**RAI 03.07.01-27, Supplement 1, Revision 1**

**Follow-up Question to RAI 03.07.01-19 (STP-NRC-100093)**

**REVISED SUPPLEMENTAL RESPONSE:**

**RAI 03.07.01-27, Supplement 2, Revision 1**

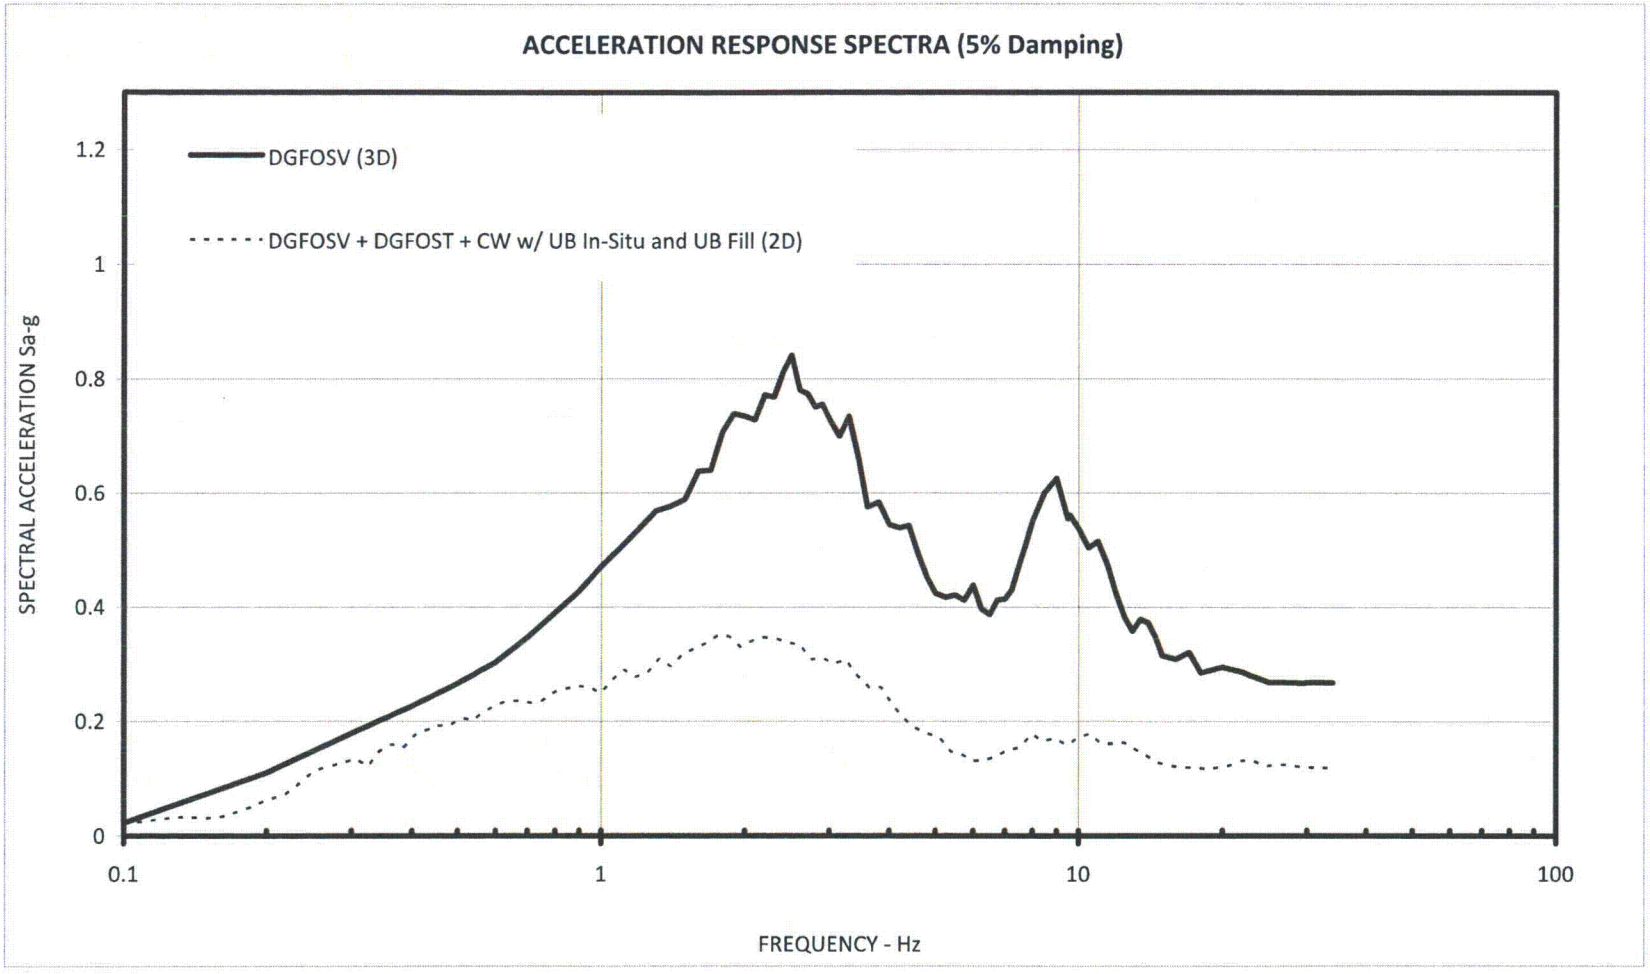
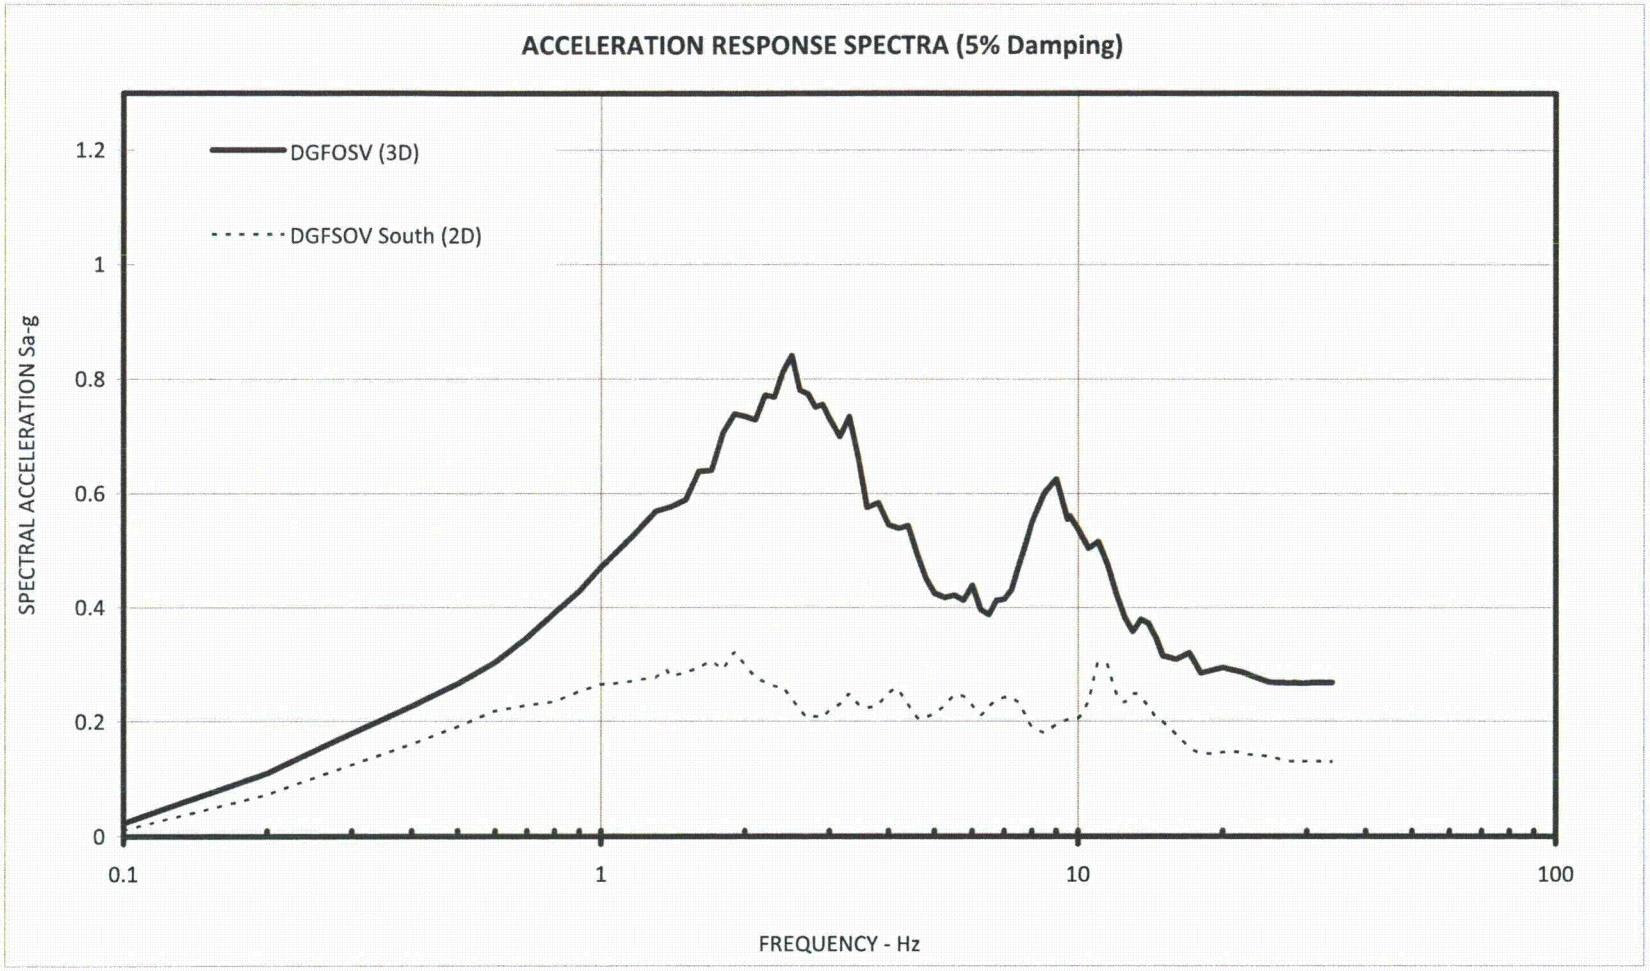
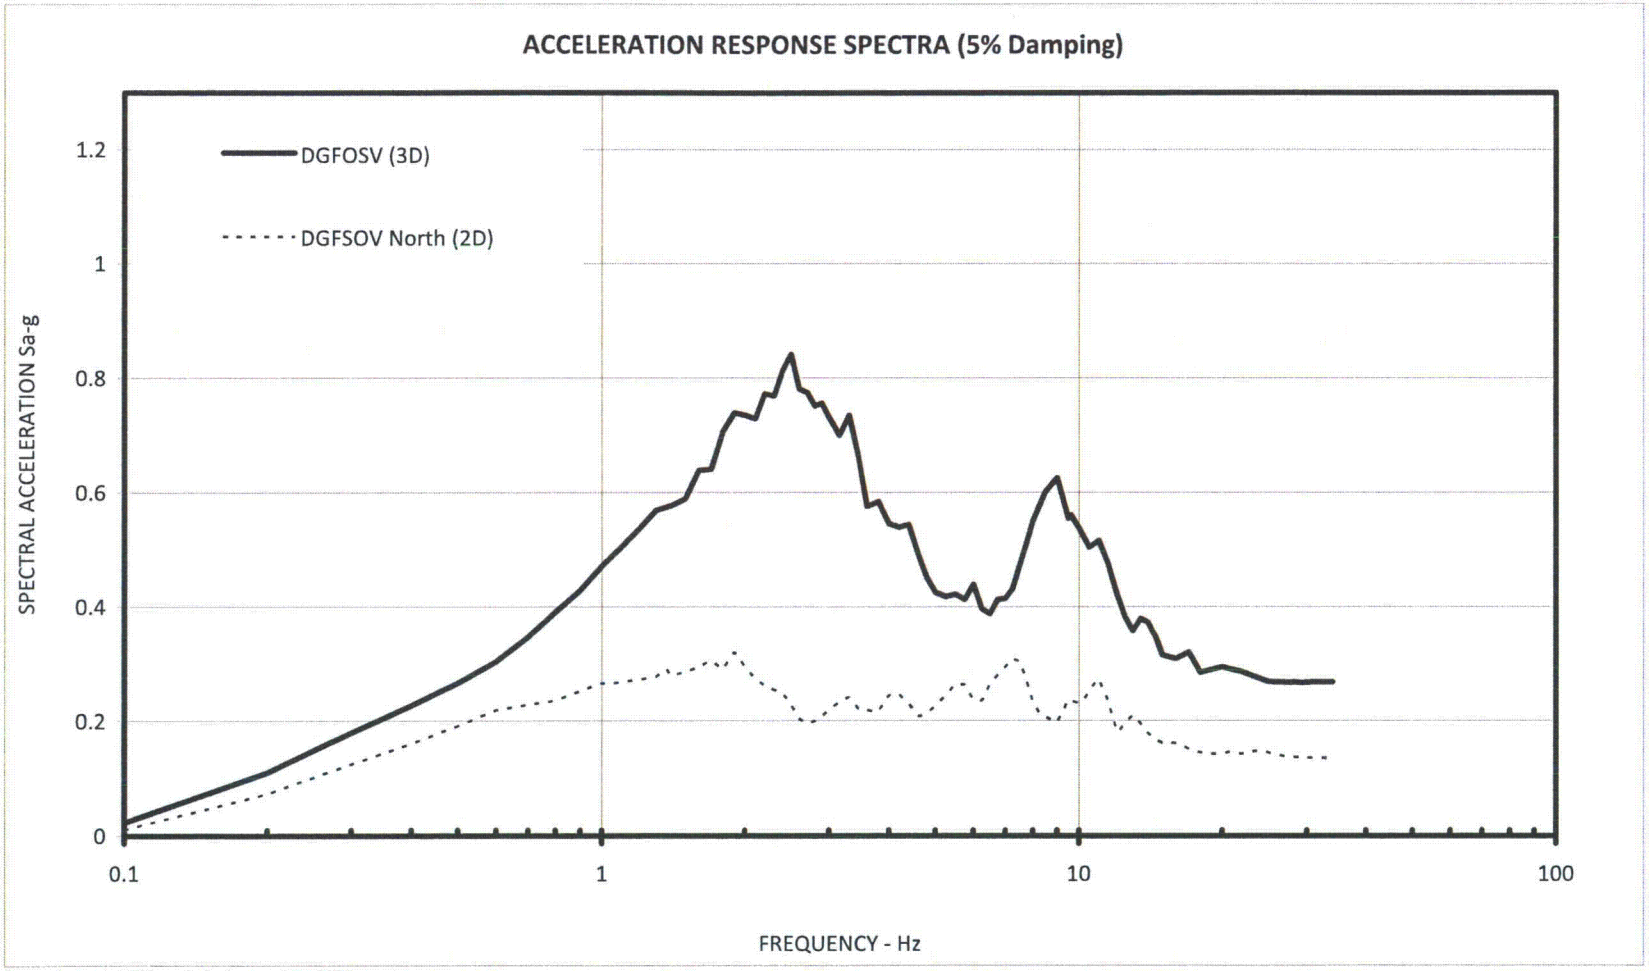
(c) Demonstrate that the DGFOSV foundation response spectra and dynamic soil pressure (on DGFOSV basement walls using ASCE 4-98 criteria) used in the design of DGFOSV will envelop the results of structure to structure (SSSI) interaction analysis which explicitly models DGFOSV structure in the SSI model of RB and the RSW Pump House structure.

Figures 03.07.01-27.25, 03.07.01-27.26 and 03.07.01-27.27 show the comparisons between the DGFOSV foundation level 5% damped response spectra obtained from the 3D SSI analysis (enveloped for all soil cases and used for the design of the DGFOSV) and the 5% damped foundation spectra obtained from 2D SSSI analyses. The comparisons show that the design spectra obtained from the 3D SSI analyses envelop the spectra obtained from the 2D SSSI analyses. Note that the input motion for the 3D SSI analysis corresponds to 0.3g Regulatory Guide 1.60 spectra, and the input motion for 2D SSSI analysis is the site specific SSE.

1c. The comparison of the DGFOSV foundation response spectra from 3D SSI analysis and 2D SSSI analysis is provided in Part 1a above.

**Figure 3H.6-221: Partial Site Plan**

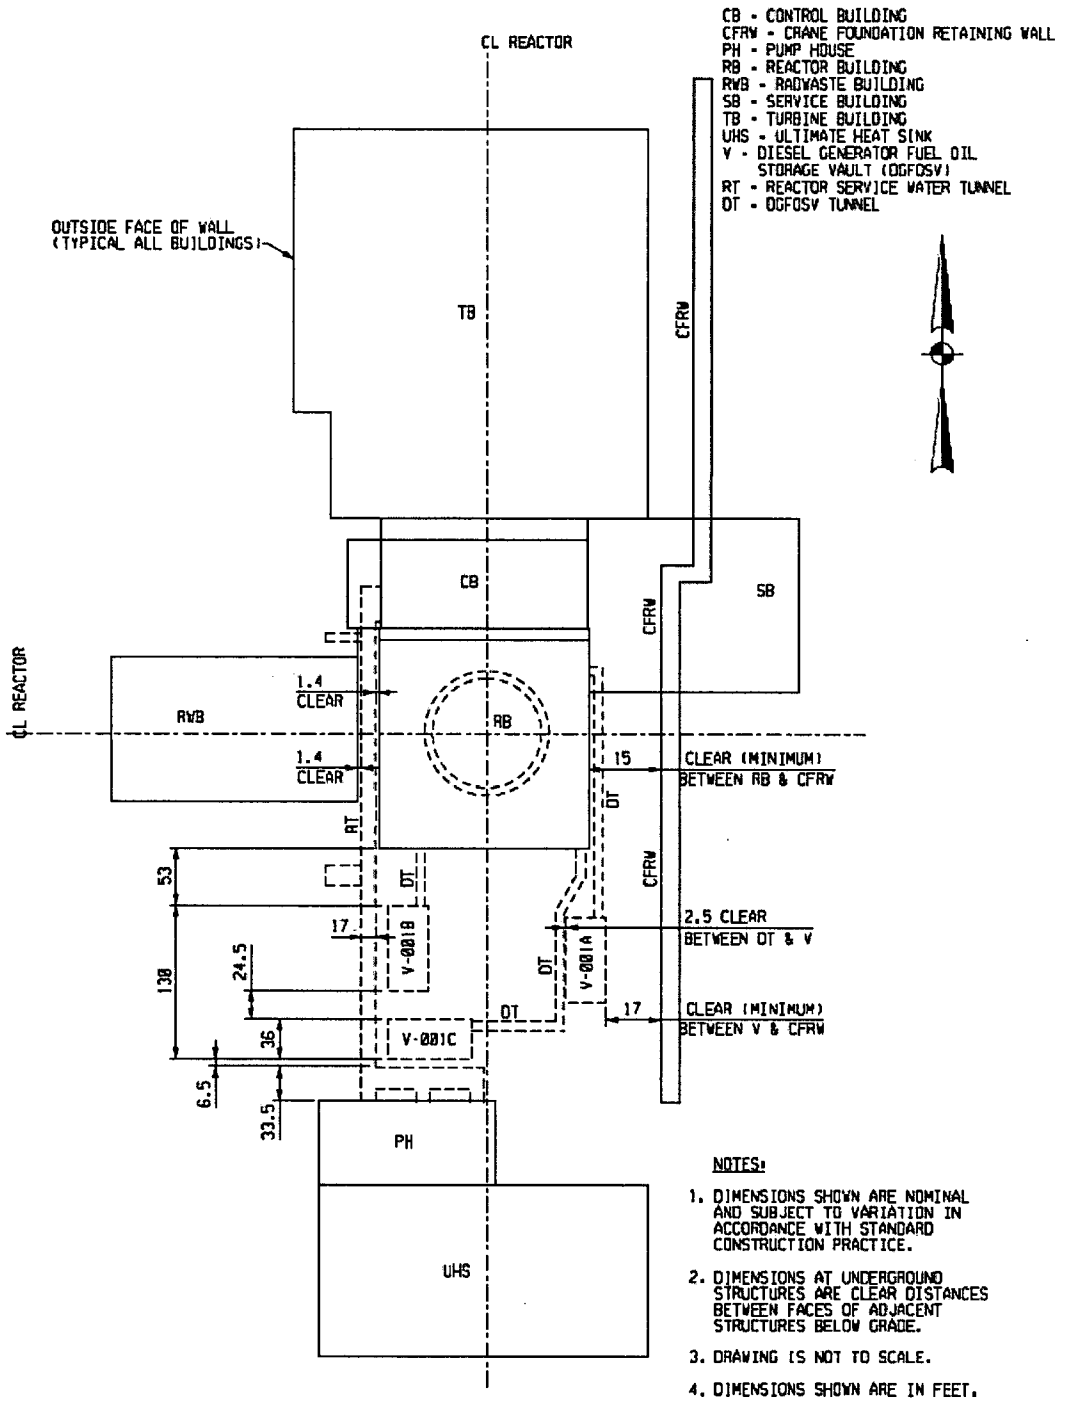
(d) Describe in detail if there is any Category I tunnel structure for transporting Diesel Fuel Oil between DGFOSV and the Diesel Generator located in other buildings including its layout and configuration and seismic analysis and design method.

The DGFOSV are reinforced concrete structures, located below grade with an access room above grade. The DGFSOV house fuel oil tanks and transfer pumps. The locations of the DGFOSV and nearby structures are shown in Figure 3H.6-221 (see Enclosure 1).

1(d). The layout of the Diesel Generator Fuel Oil Tunnels (DGFOTs) is as shown in COLA Part 2, Tier 2 Figure 3H.6-221 provided in response to Part 1(a) of this RAI. There are three (3) reinforced concrete DGFOTs approximately 50 ft, 200 ft, and 220 ft long for each unit. Each DGFOT is connected at one end to the Reactor Building (RB) and at the other end to a Diesel Generator Fuel Oil Storage Vault (DGFOSV). There is a seismic gap between each of the tunnels and the adjoining RB or DGFOSV. For magnitude of the required and provided seismic gaps at interface of DGFOTs and the adjoining RB and DGFOSVs, see the Supplement 1, Revision 1 response to RAI 03.08.04-31 which was submitted with NINA letter U7-C-NINA-NRC-110008 dated January 31, 2011.

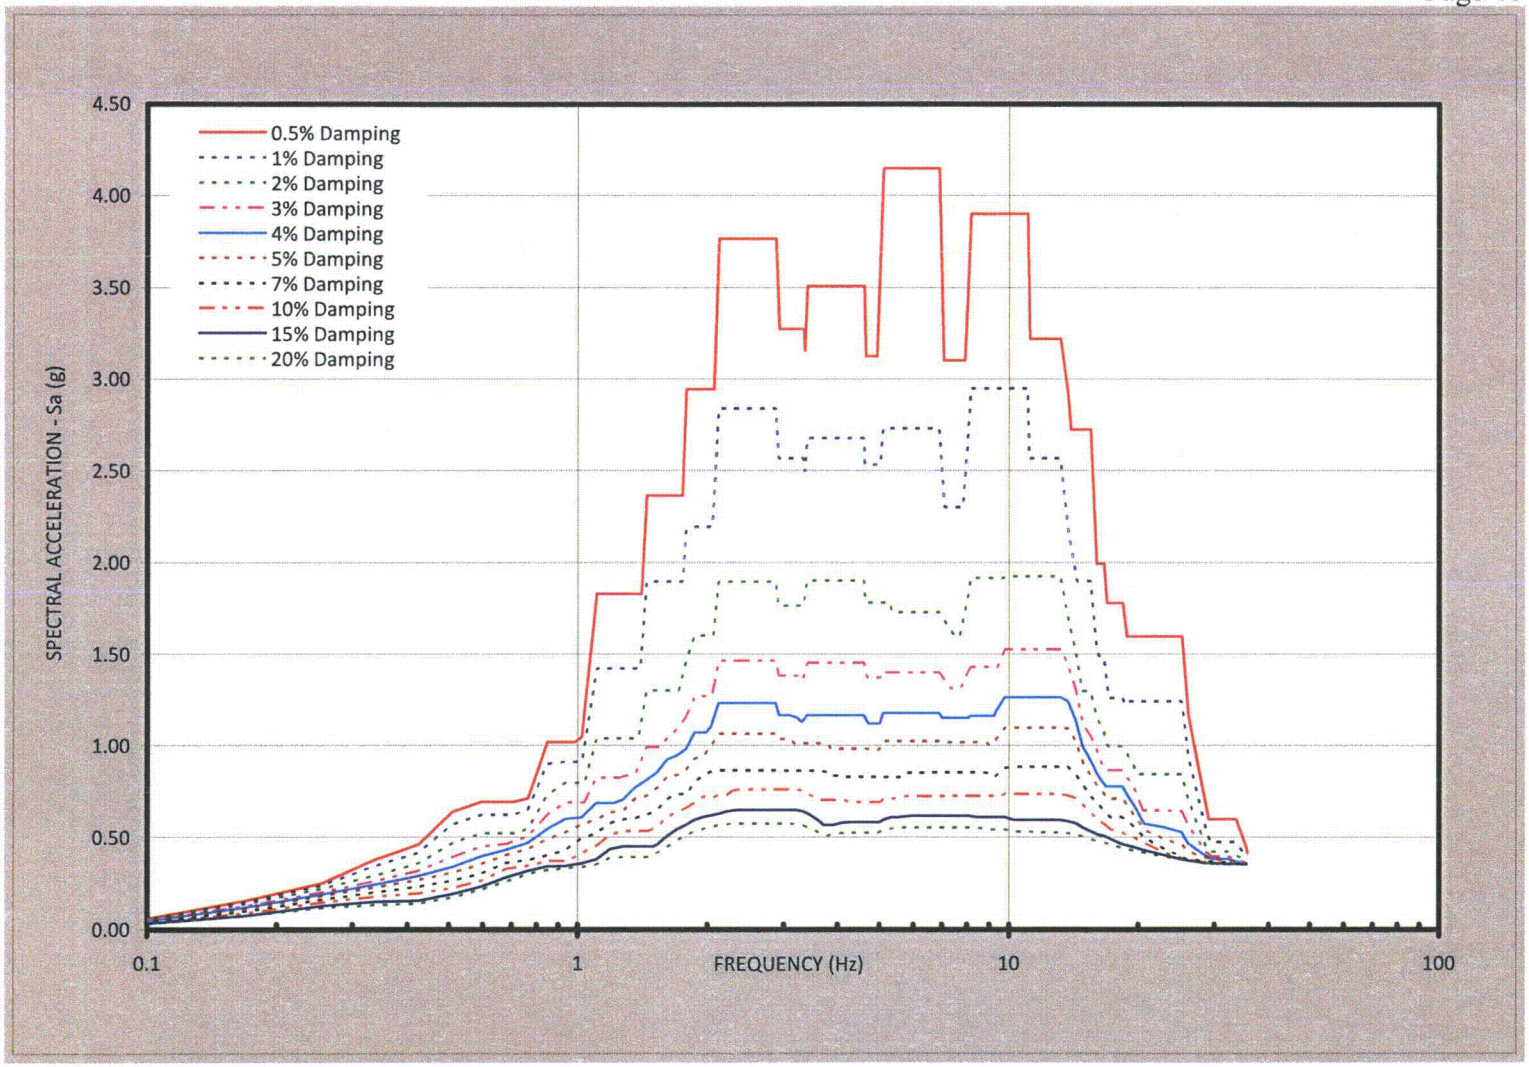
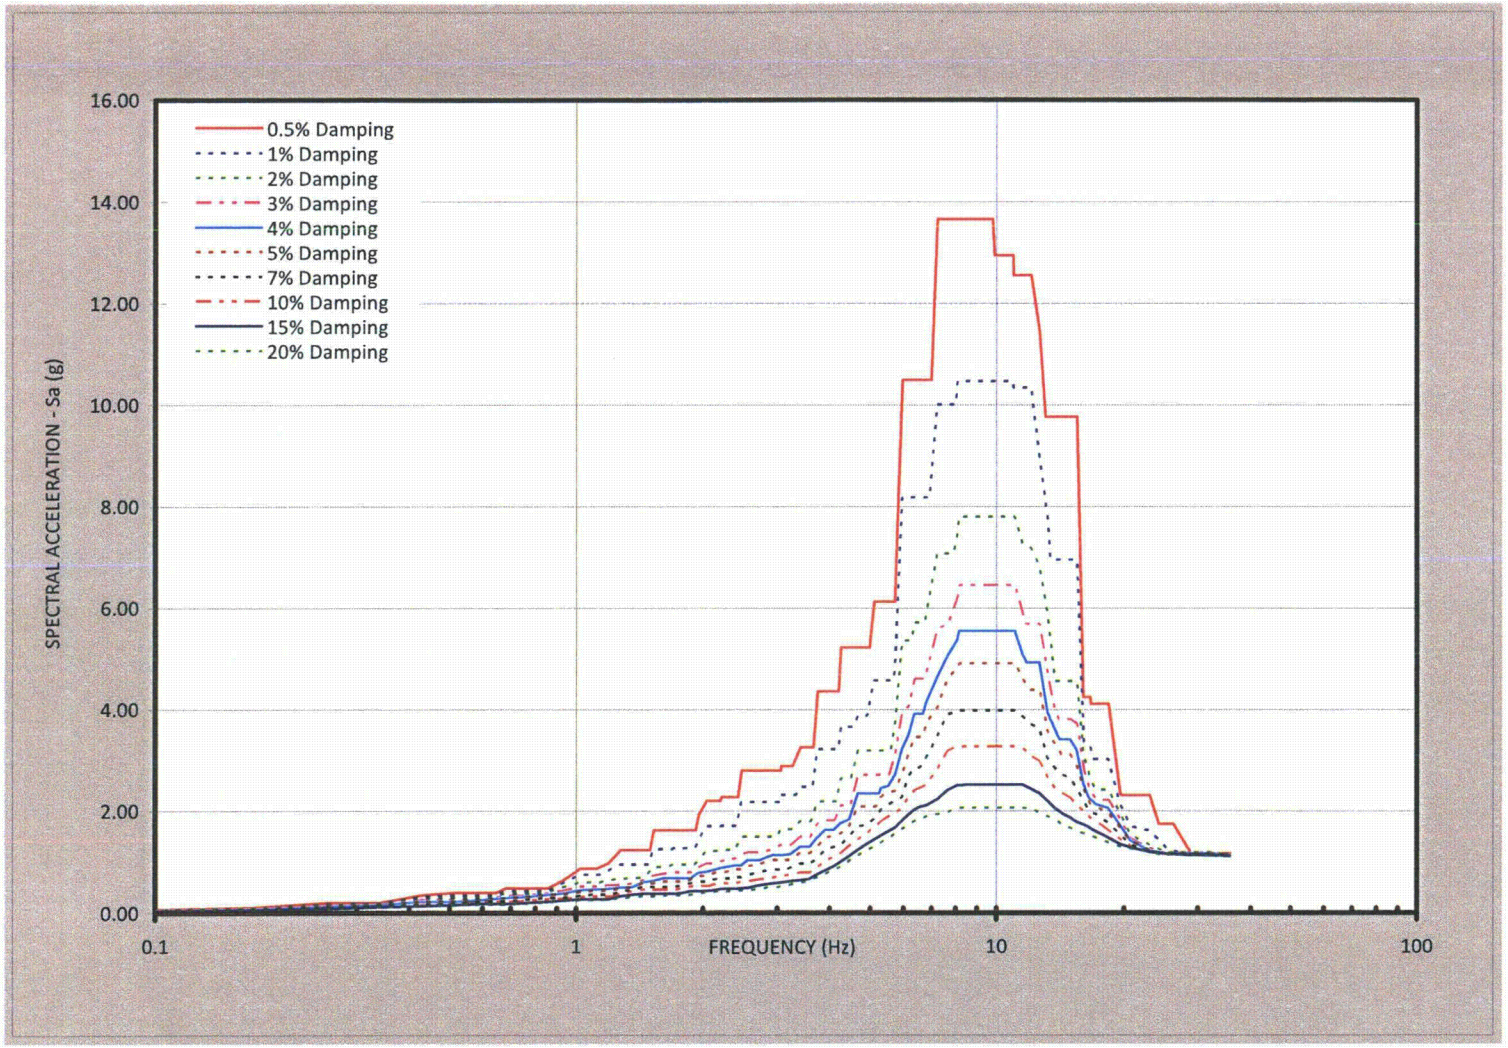
1. 10CFR50, Appendix S requires that evaluation for SSE must take into account soil-structure interaction (SSI) effects and the expected duration of vibratory motion. In the response to the first paragraph of RAI 03.07.01-19, the applicant has presented its approach for developing the input motion for the SSI analysis and design of the DGFOSV that takes into account the impact of the nearby heavy RB and RSW Pump House structures. The applicant also stated that *"Conservatively, a 3-dimensional SAP2000 response spectrum analysis was used to obtain the safe-shutdown earthquake (SSE) design forces due to structure inertia. The seismic induced dynamic soil pressure on DGFOSV walls were computed using the method of ASCE 4-98, Subsection 3.5.3.2"* The response, however, does not provide details as to how the SSI analysis of the DGFOSV are performed and how the input motion developed are subsequently specified in the SSI analysis of DGFOSV to develop the structural response and in-structure response spectra for any equipment and subsystems within DGFOSV. From the response it appears that the applicant has not included explicitly DGFOSV structural model in the SASSI model of the RB and RSW Pump House structures to properly evaluate the SSSI effect on the DGFOSV. In order for the staff to determine if the evaluation of DGFOSV for SSE has appropriately accounted SSI effects, the applicant is requested to provide in the FSAR the following information:

For all analysis cases, the responses due to two horizontal directions and vertical direction input motions are combined using square-root sum of squares (SRSS) method. Then, the responses from all analysis cases and all locations considered for spectra generation are enveloped to determine one set of un-widened horizontal and vertical response spectra. Finally, per Regulatory Guide 1.122, the enveloped un-widened response spectra are peak widened by plus-minus 15% on the frequency scale to obtain the final response spectra for DGFOSV. The resulting enveloping response spectra for DGFOSV are shown in Figures 3H.6-223 and 3H.6-224 (see Enclosure 1).
